## ADDENDUM

NO. 01

**PROJECT NAME:** 2025 Multi-Campus Chiller Replacement

**CLIENT NAME:** Cypress-Fairbanks ISD

**ELECTRICAL KEYED NOTES - E1.01**

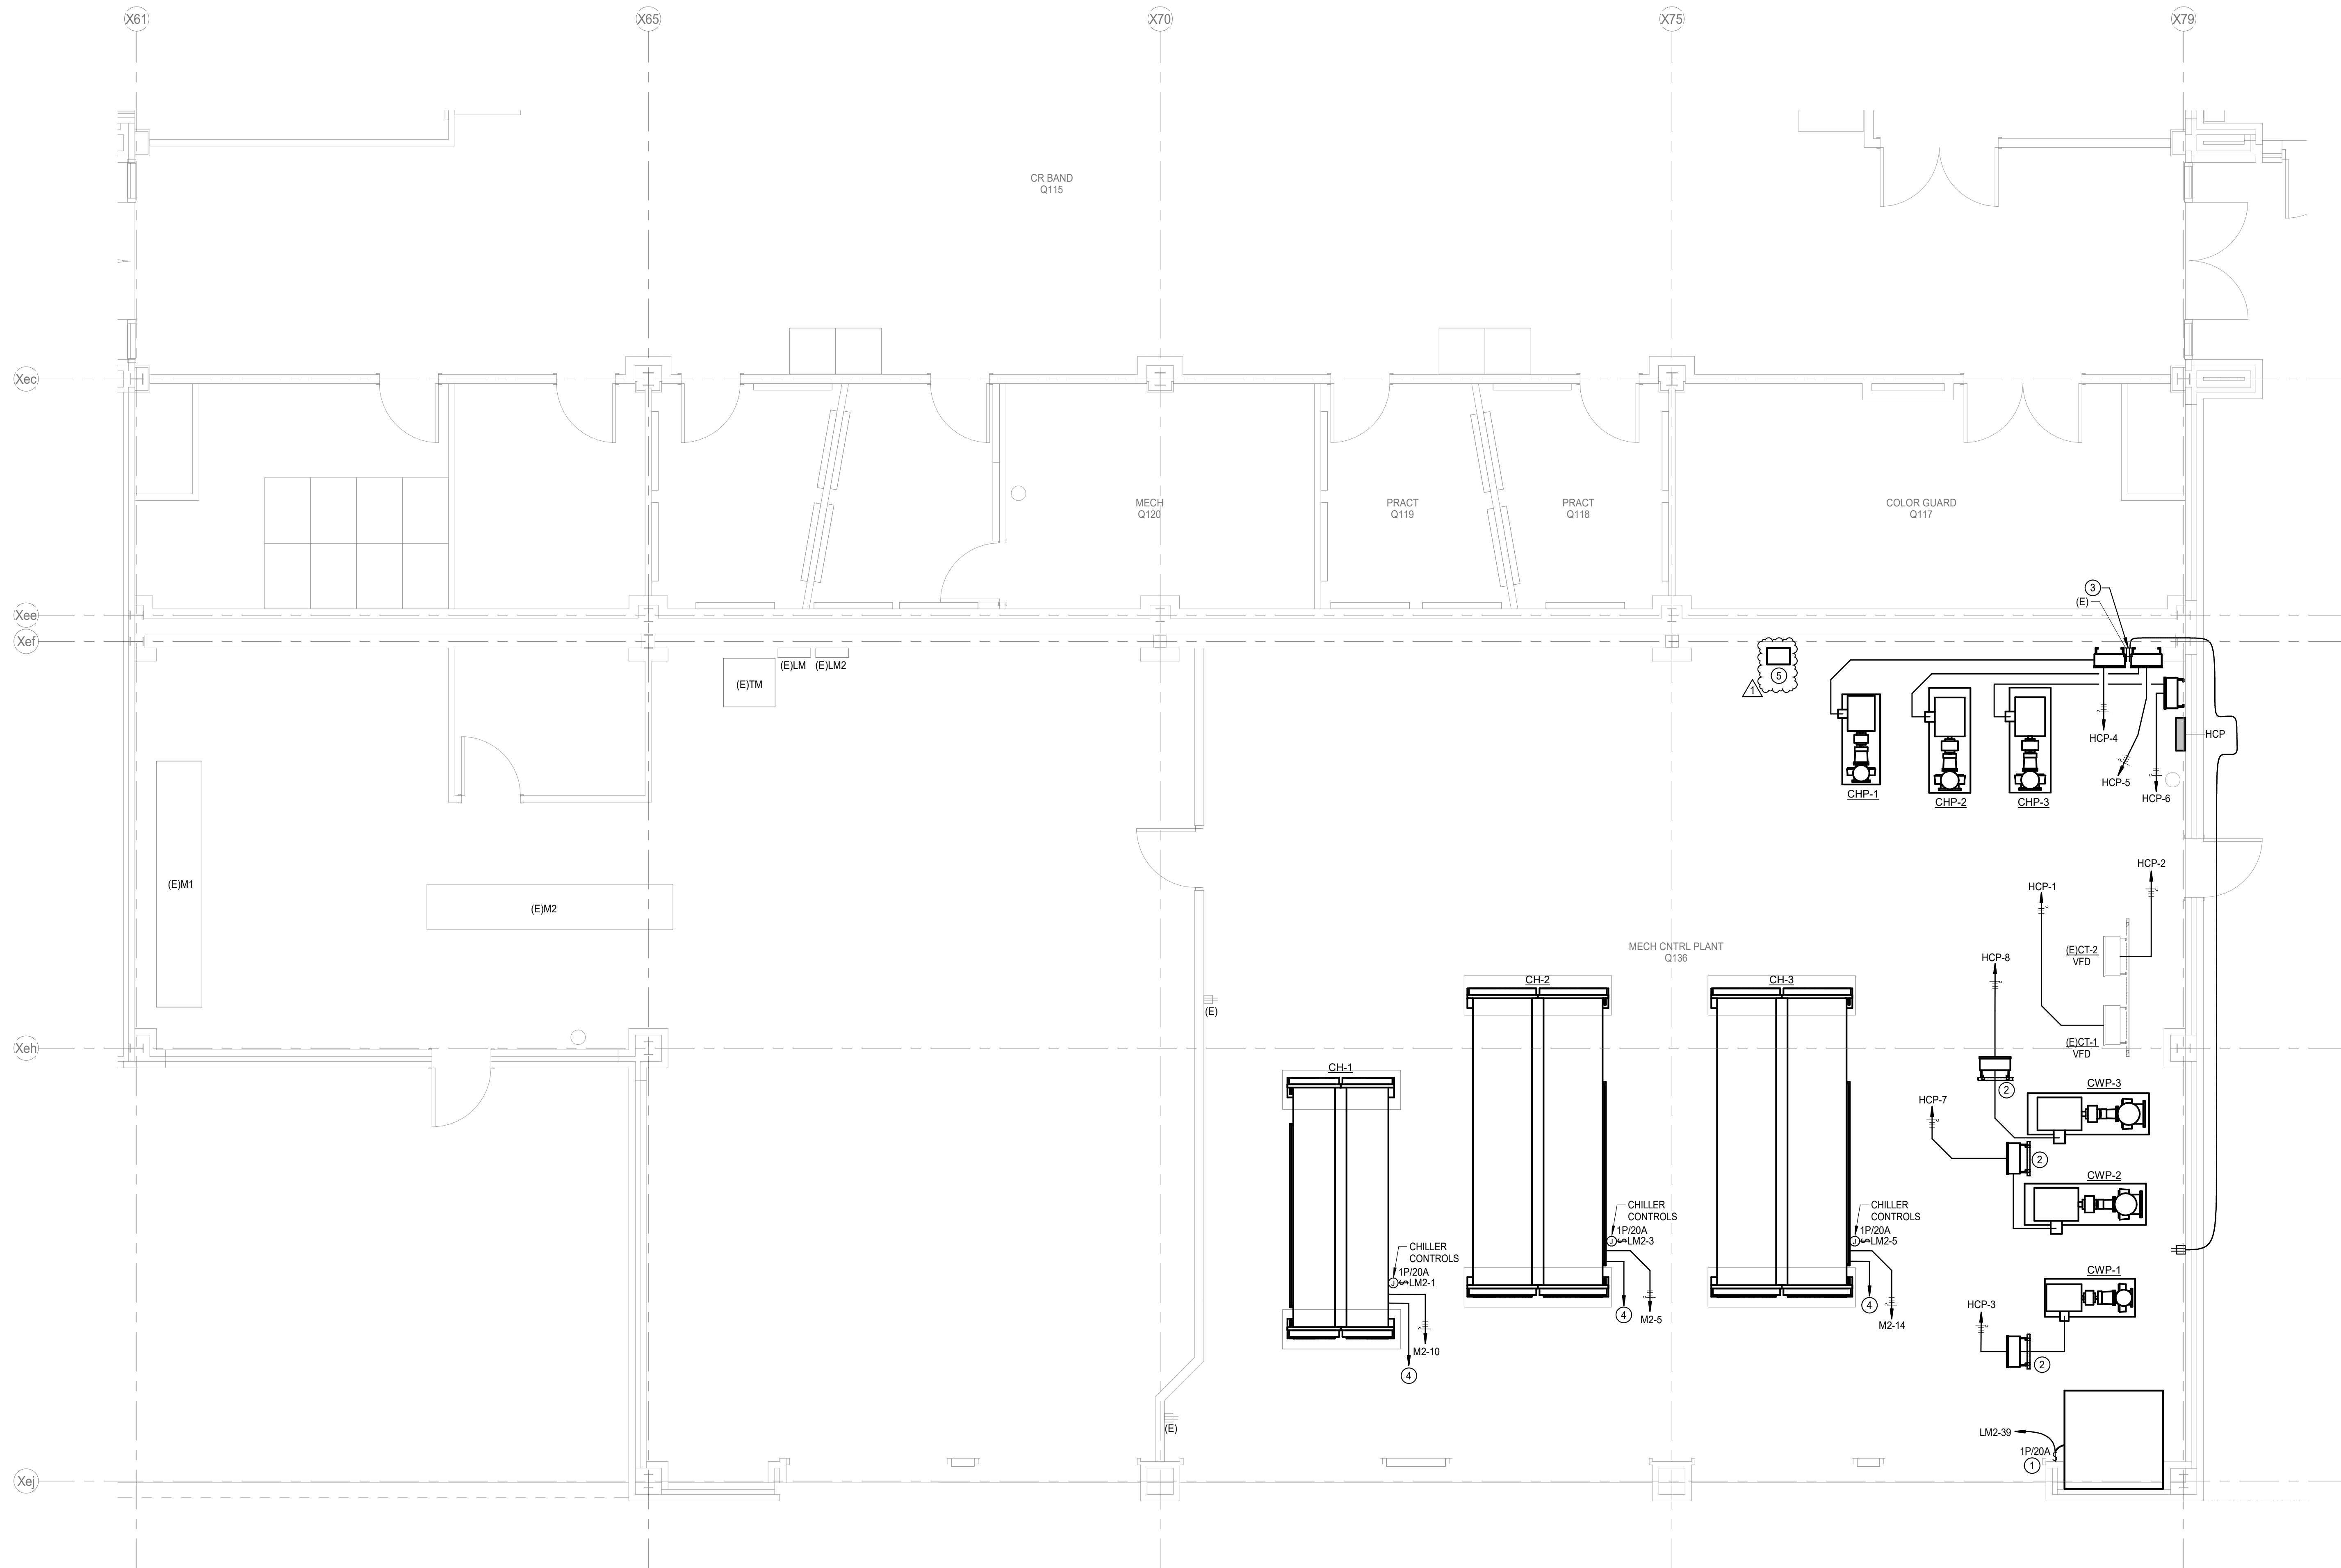
AD No 2, Elec. Item 2: **To the Drawings, Sheet E1.01-JV, "E1.01-JV - ELECTRICAL DEMO ENLARGED PLAN - SERVICE YARD"**

- a. Refer to attached drawing for disconnect of existing refrigerant monitoring.
